**Re: Letter of Notification of Duquesne Light Company, Filed Pursuant to 52 Pa. Code Chapter 57 Subchapter G, for Approval of the Cheswick-Plum Reconfiguration Project in Plum Borough, Allegheny County, Pennsylvania.- Data Requests Docket No. A-2023-3042138**

**Bureau of Technical Utility Services**  
**Data Requests**  
Docket No. A-2023-3042138

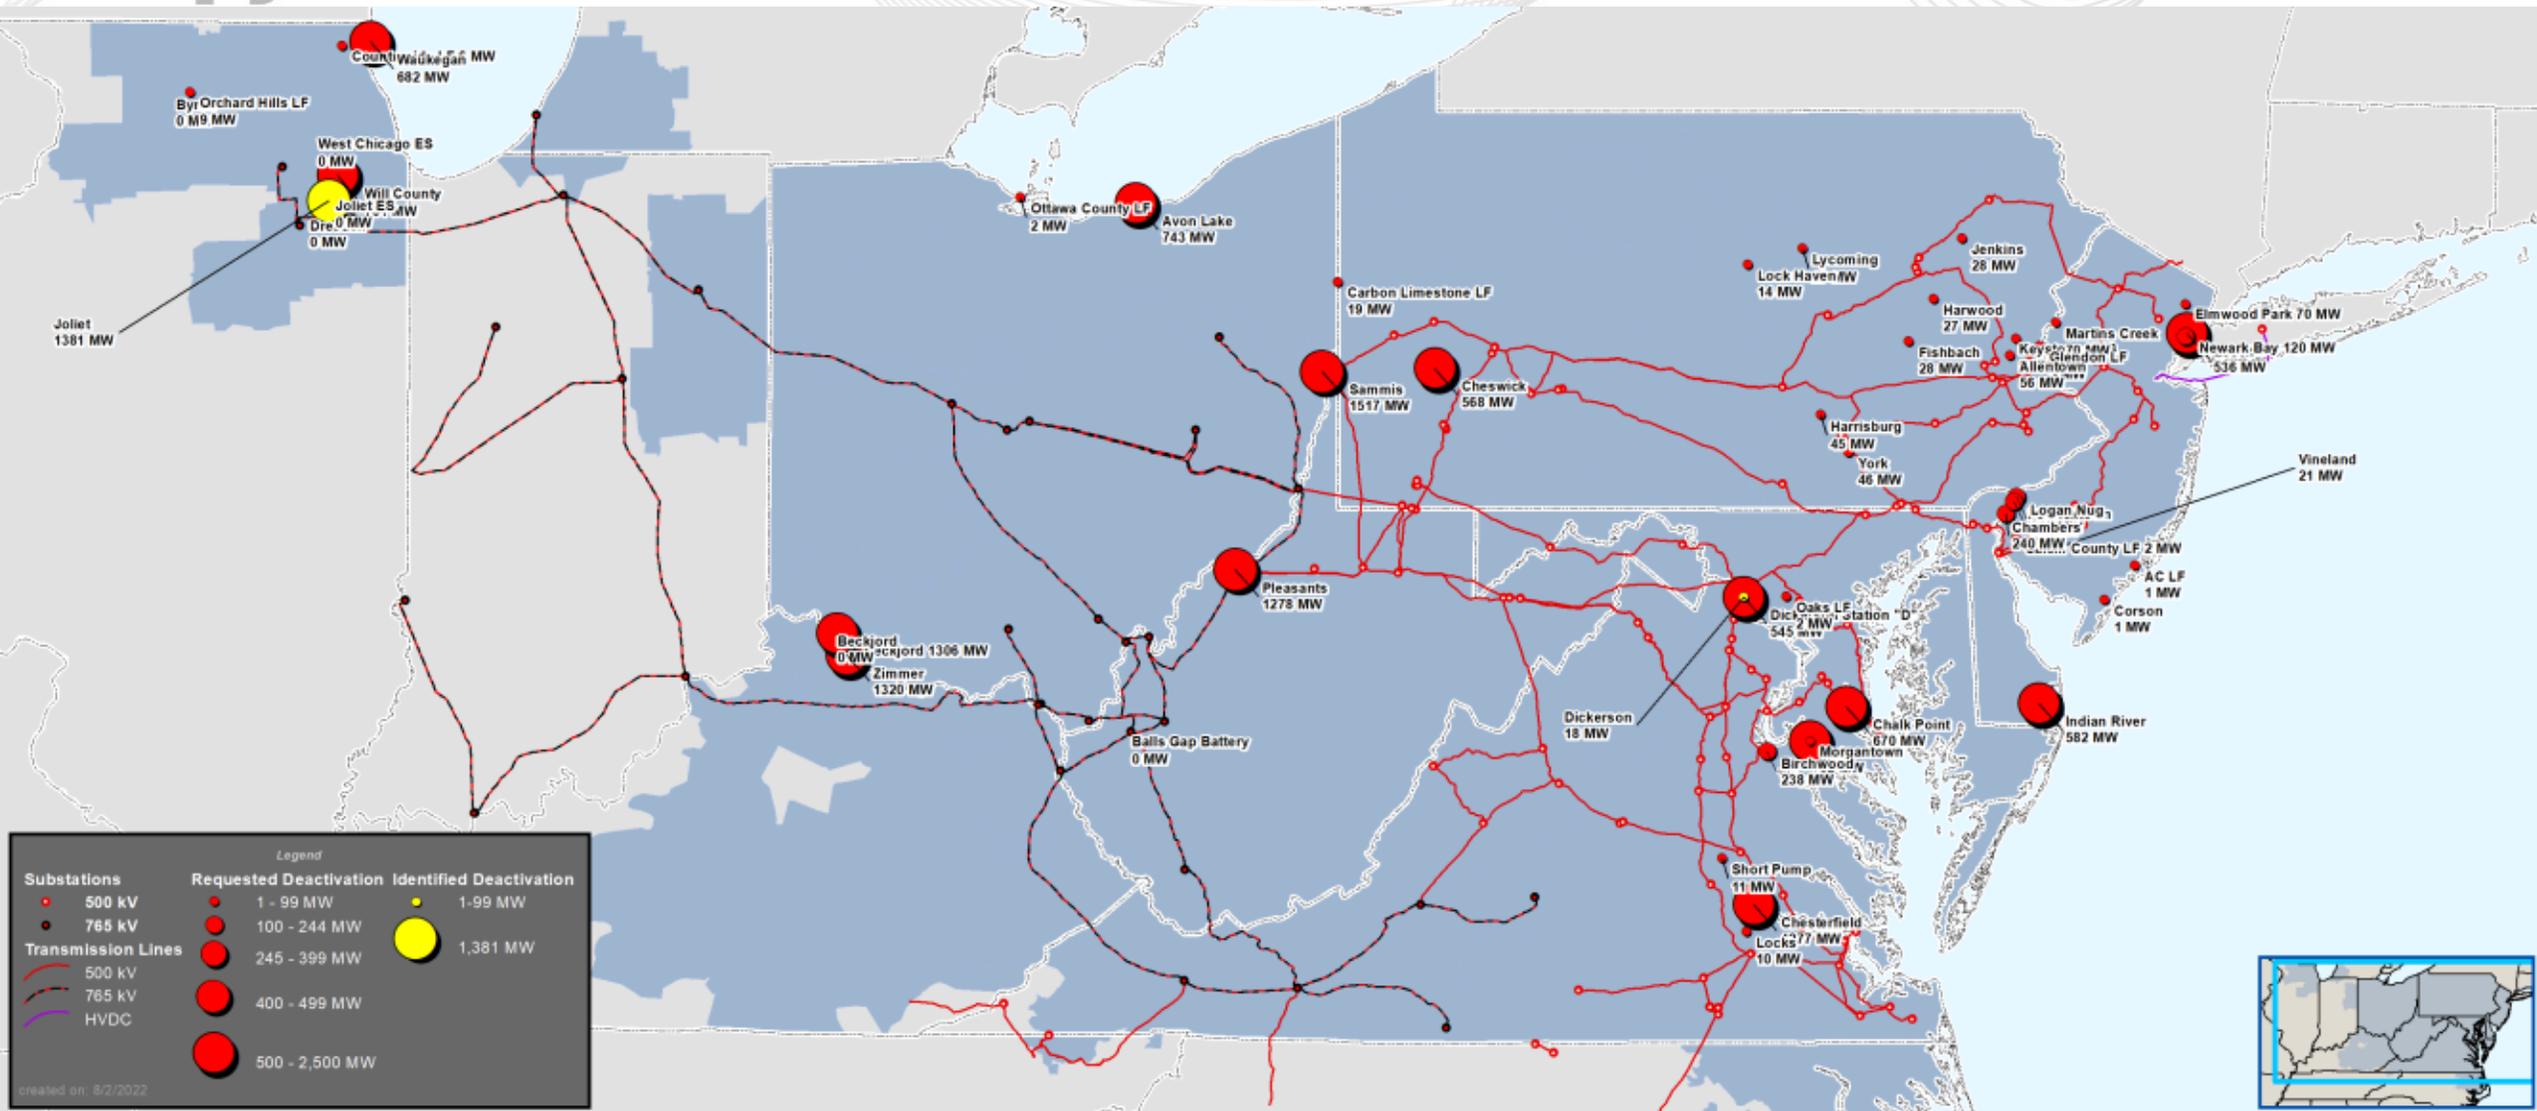
**A-1** Reference the Letter of Notification, Paragraph 11. Please provide a detailed description of the violations (e.g., thermal, voltage, etc.) and the transmission facilities on which the violations occur.

The deactivation of the Cheswick Generating Station in the northeast portion of the Duquesne Light system resulted in increased power flows from the southern tie lines into the southern and central portions of the Duquesne Light system. The N-1-1 analysis conducted by PJM and Duquesne Light identified that the change in transmission system flows could result in reliability criteria violations on Duquesne Light's transmission system, identified in footnote 6 of the Letter of Notification. The N-1-1 analysis identified the potential for thermal violations based on contingencies outlined in TPL-001-4, P3 and TPL-001-4, P6.

The summary of the N-1-1 analysis, referenced in footnote 2 of the Letter of Notification, is included with this response and identified as "A-1 Attachment." As shown on slide 4 of "A-1 Attachment," potential thermal violations were identified on four transmission lines: Collier-Elwyn (Z-62), Collier-Elwyn (Z-162), Carson-Oakland (Z-86), and Forbes-Oakland (Z-48).

B3717.1: Install a series reactor on Cheswick - Springdale 138 kV line.

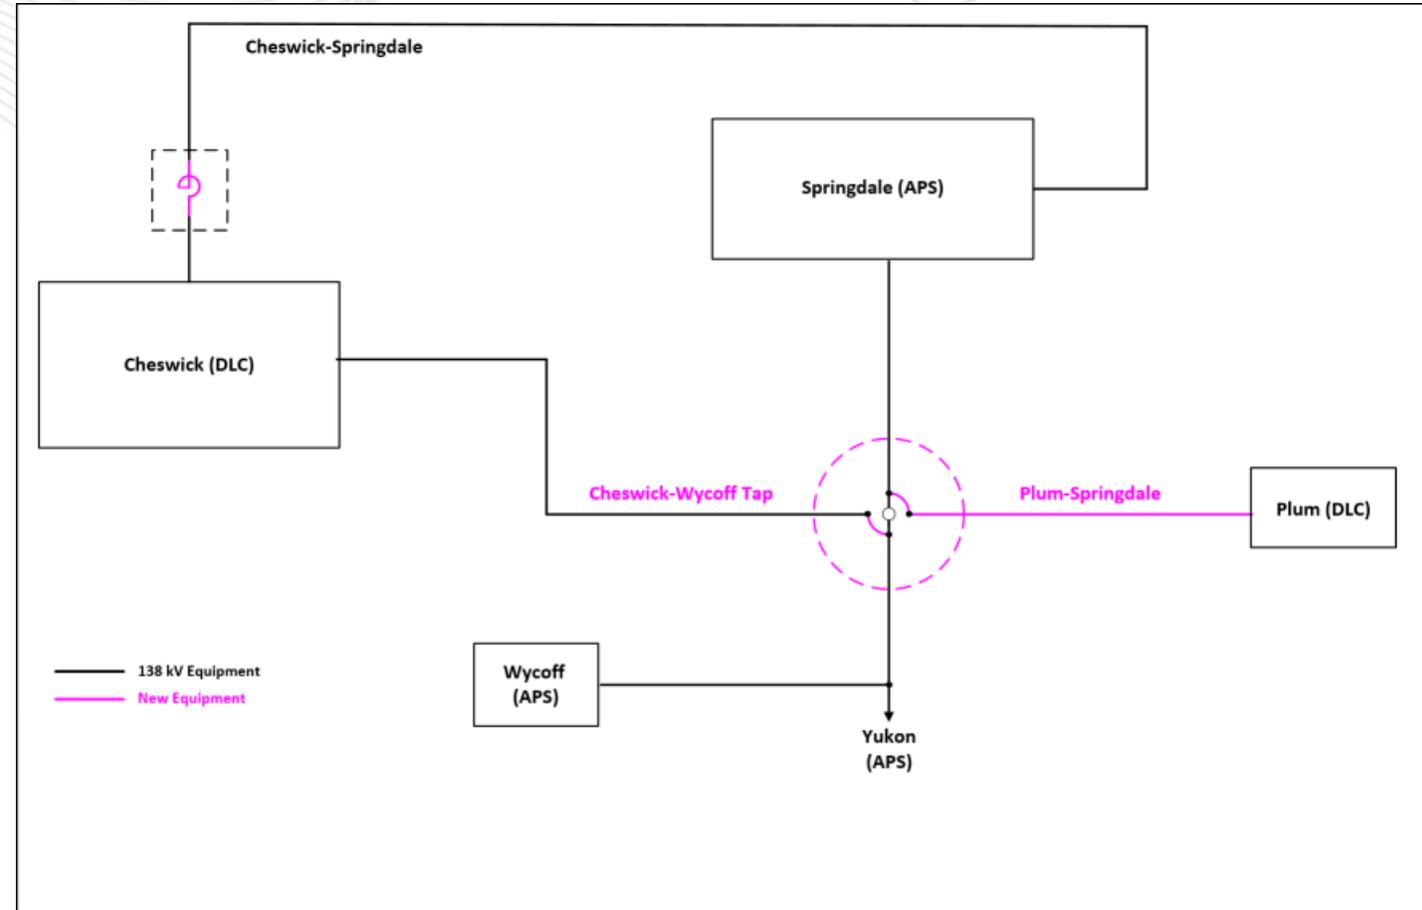
## Problem Statement:

- Thermal violation:
  - Collier - Elwyn #1 138 KV
  - Collier - Elwyn #2 138 KV
  - Forbes - Oakland 138 KV
  - Carson - Oakland 138 KV
- Contingency: Various N-1-1

B3717.2: Transmission Line Rearrangement

- Replacement of four structures and reconductor DLCO portion of Plum – Springdale 138 kV line.
- Associated communication and relay setting changes at Plum and Cheswick.
- Current Rating: 220 MVA SN/ 248 MVA SE
- New Rating: 288 MVA SN/ 343 MVA SE
